**Proposed Truck Stop  
Barnetby, Lincolnshire**

**CGQ/210457/TN/2 - 22 September 2022**

**Introduction**

**Figure 1: Eastern Site Access Amended General Arrangement**

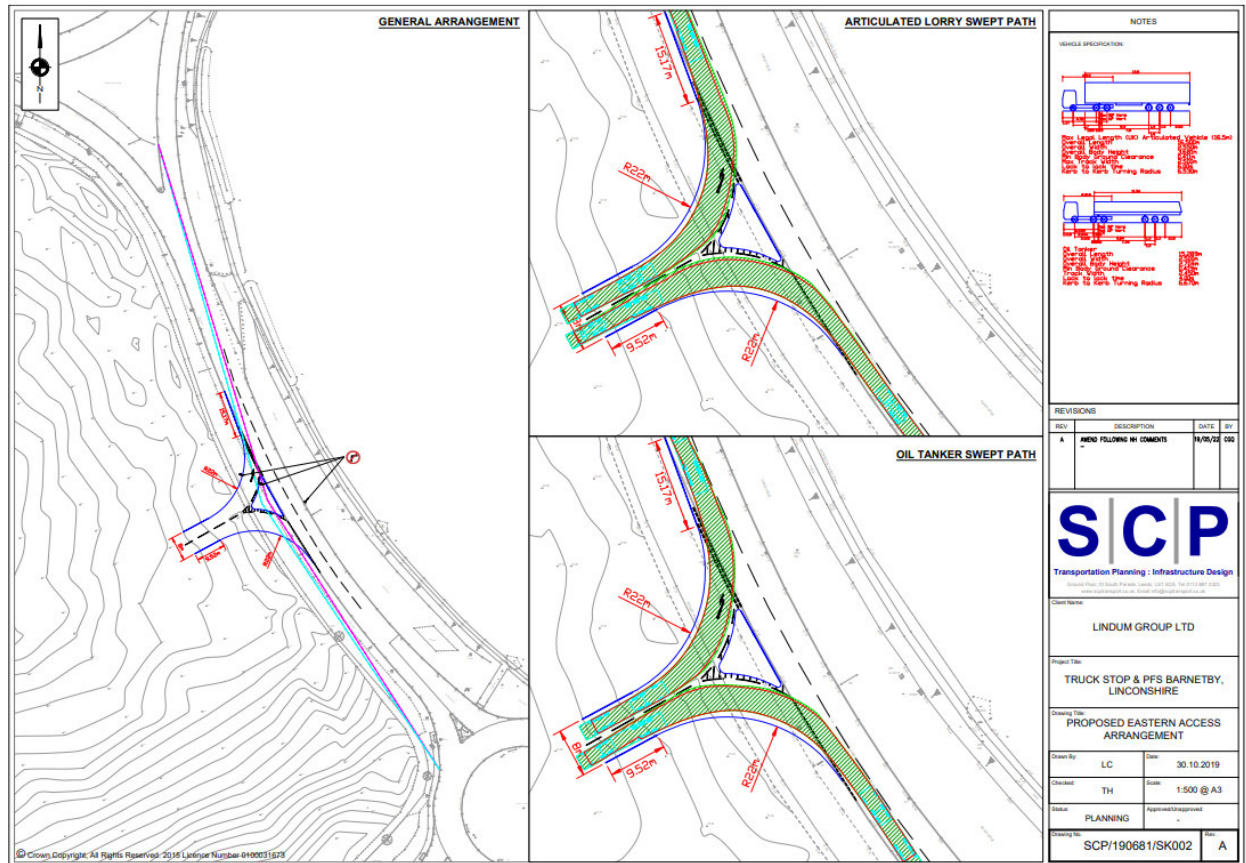
4. This Technical Note details the response to the issues raised by NH. The issues raised which are to be addressed were as follows:
  - i) National Highways note that the traffic island proposed at the northern site access is small, presenting a low impact deterrent for right turners. It is considered that with the access design provided, there will still be a proportion of customers that would not adhere to the left in left out restriction.

- 6. The proposed eastern access arrangement consists of a left in and left out only arrangement. There is no central island on the main carriageway (the A18) and therefore a right turn should be discouraged as much as possible.
- 7. The proposed site access general arrangement has been amended to make the possibility of right turn manoeuvres more challenging to execute. This has been achieved by increasing the

size of the separation island and adjusting the angle of the exit and entry to dissuade right turning. The amended general arrangement is shown at **Figure 1** below and a full scaled version is attached at **Appendix 2**.

**Figure 3: M180/A180 Interchange Southern Approach Indicative Visibility Screen**

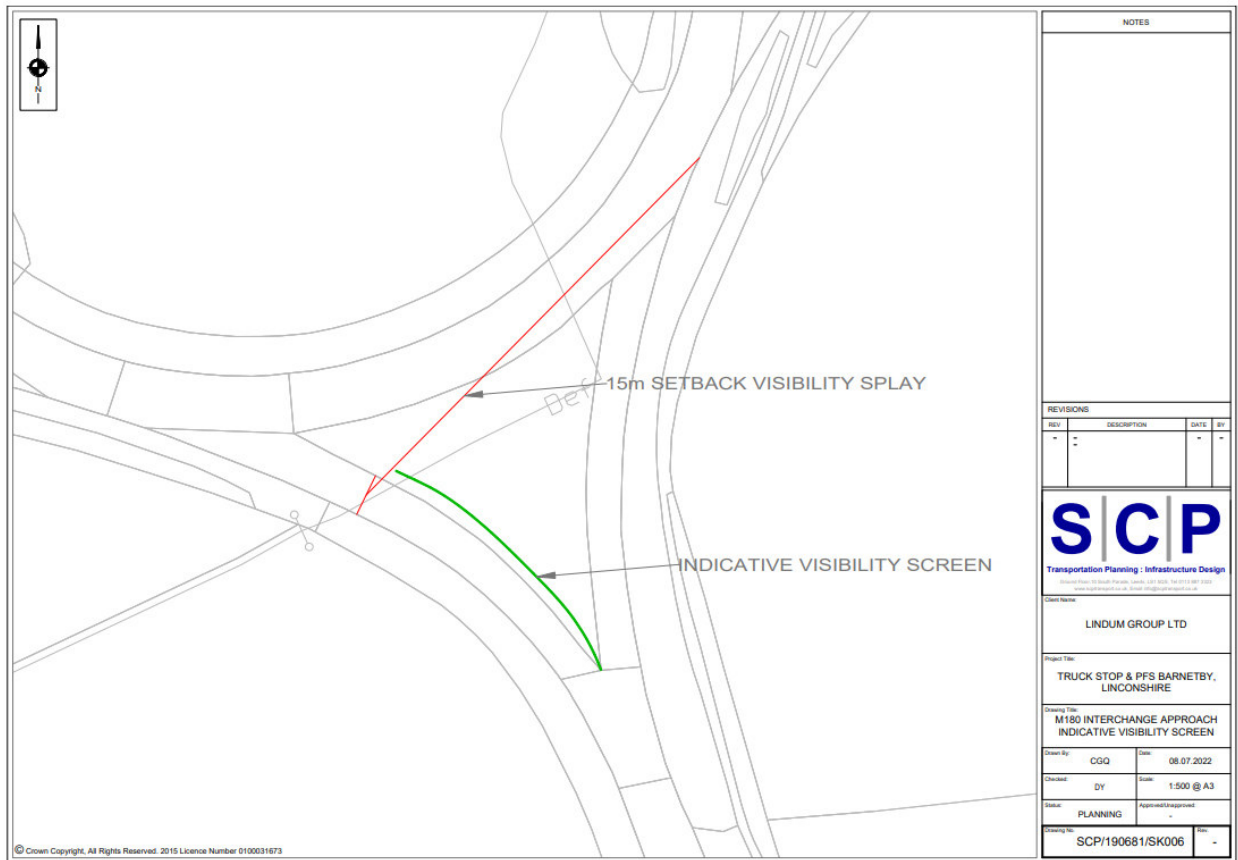
- ii) There is a history of accidents of similar circumstance on the A15 / M180 / Barnetby Lane Link Road Gyratory. Considering the impact of the proposed development, the applicant should undertake a detailed assessment of the A180 junction and explore safety increasing measures at the junction approaches to reduce the frequency of

'driver error' incidents to ensure that the observed high frequency of collisions is not exacerbated considering the increased traffic turning movements that the proposed development would generate.

13. Having reviewed the personal injury collision data in the TA, the risk of collisions on the southern approach to the interchange could be exacerbated by the left-out only eastern access to the site. It is proposed that a potential increased risk in terms of road safety is mitigated by increasing the length and position of the visibility screen which is currently on the approach to the roundabout. A visibility screen is commonly used on the approach to roundabouts to reduce the opportunity

for drivers to accelerate and overshoot the junction give way. The existing visibility screen is set back from the edge of the carriageway and does not include the full length of the verge on the approach to the give way. As is demonstrated in **Figure 2** below, vehicles approaching the give way have visibility of the circulatory prior to the give way which could result in drivers accelerating.

14. It is proposed to lengthen the screen and relocate the position of it so it is closer to the edge of carriageway to increase the effectiveness of the screen. A plan showing an indicative visibility screen is shown at **Figure 3**, over and a full scaled version is attached at **Appendix 3**.

Figure 4: Westbound Merge

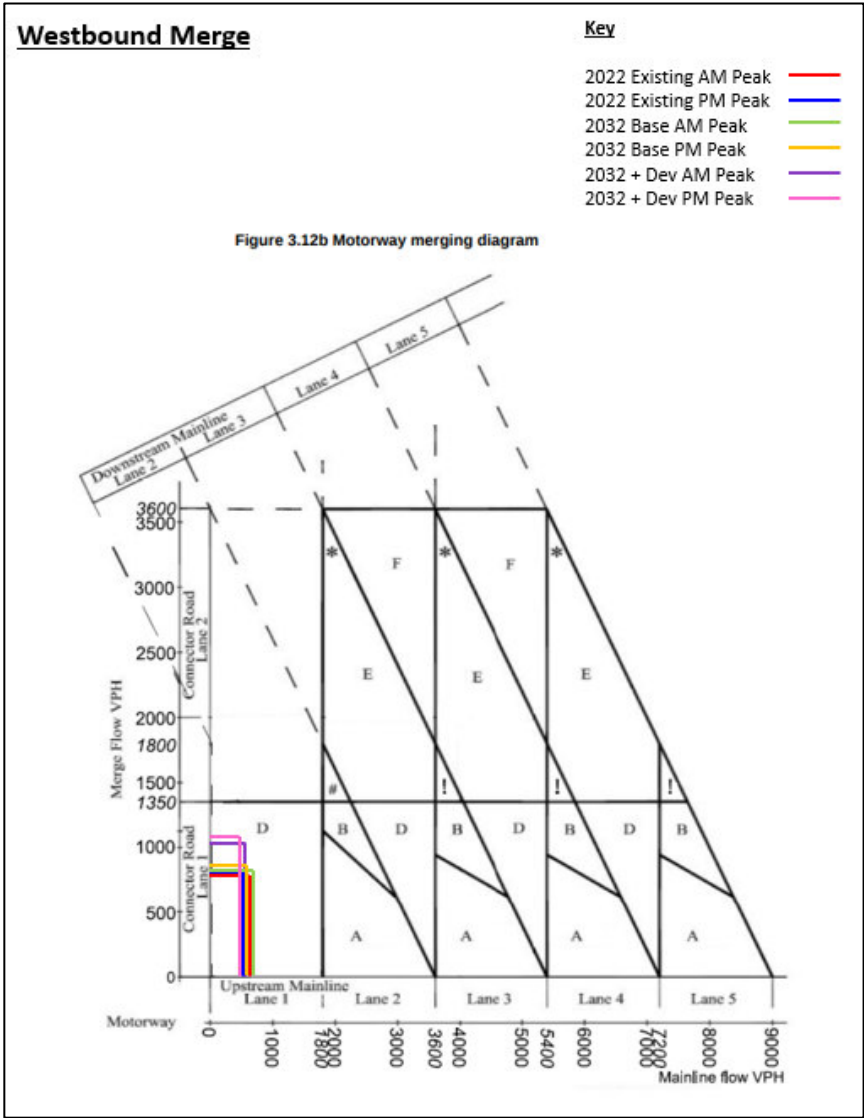
- vi) We note that there is no assessment of merge/diverge operation presented within the TA. National Highways require this assessment to confirm the safe operation of the M180 junction.

25. The traffic flows shown in Table 3 have been used to plot on the merge and diverge assessment graphs extracted from CD 122. **Figure 4** below shows the graph for each scenario on the Westbound Merge.

29. As is shown in Figures 4 to 7 above, there are no merge or diverge where the addition of development traffic or background network traffic over ten years results in any required changes to the layout and size of the M180/A180 interchange.
